**Lone Eagle Subdivision North**  
**Formal Objection to Proposed Zone Change from Agricultural to RR-3**  
**Alkali Creek / Highway 3 Area – Yellowstone County, Montana**  
**To: Billings–Yellowstone County Planning Board**  
**Date: 12/10/25**

**Summary of Objection**

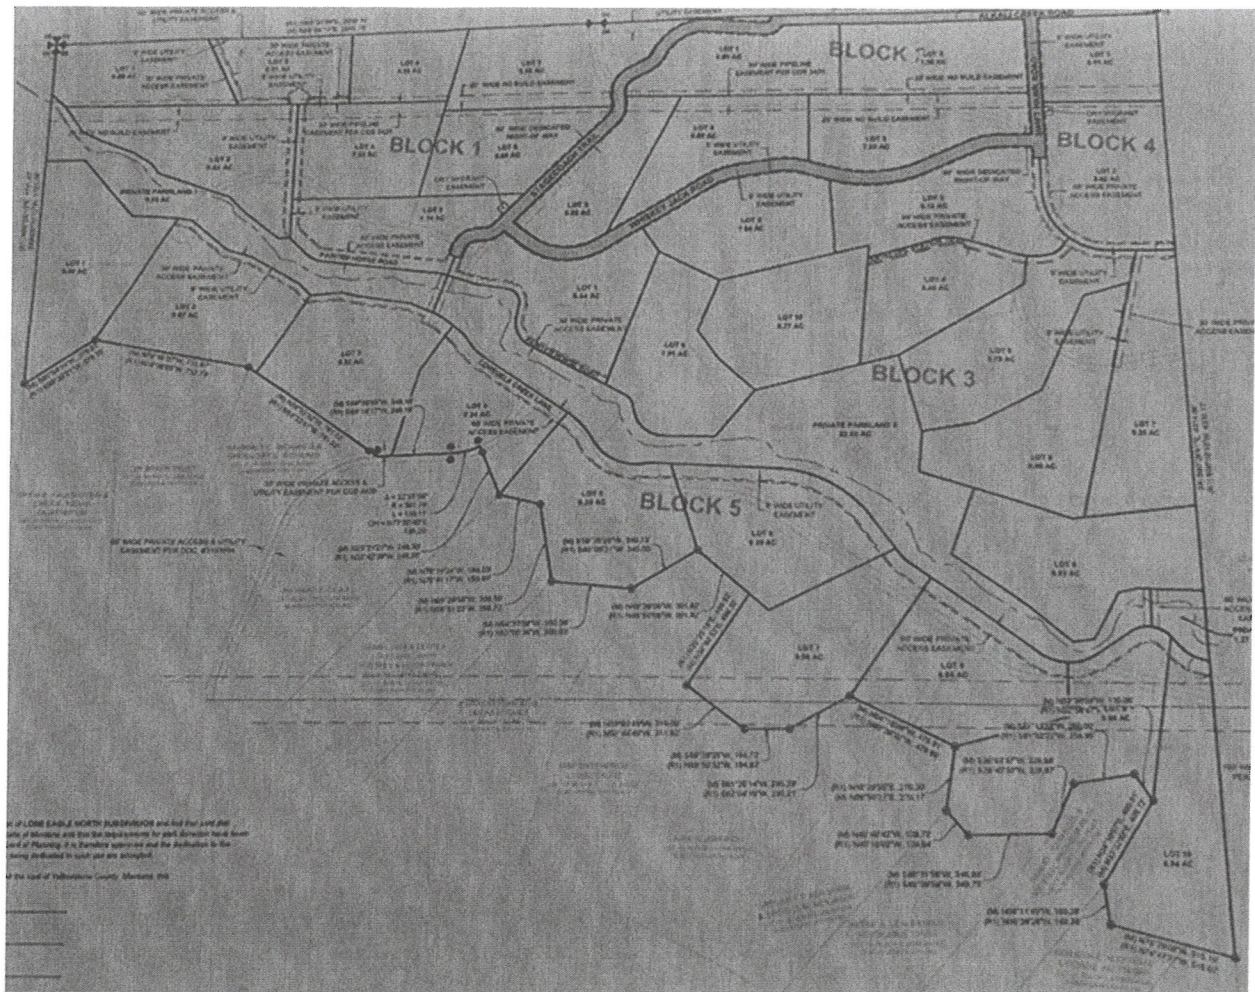
The proposed subdivision would create 36 residential lots, all under 10 acres, with an average lot size under 6.55 acres (based on initial plat (see below Exhibit B) which may have already been changed) and some as small as 4.5 acres. This represents a 53.2% reduction in average lot size compared to surrounding development.

The property is traversed by both a hazardous liquids pipeline / gas transmission pipeline, each classified as federally regulated high-consequence infrastructure. Lot sizes are further reduced adjacent to these corridors to maximize yield, increasing residential exposure near known hazards. (this may have improved with newer version of the plat proposal) If zoned RR3, the
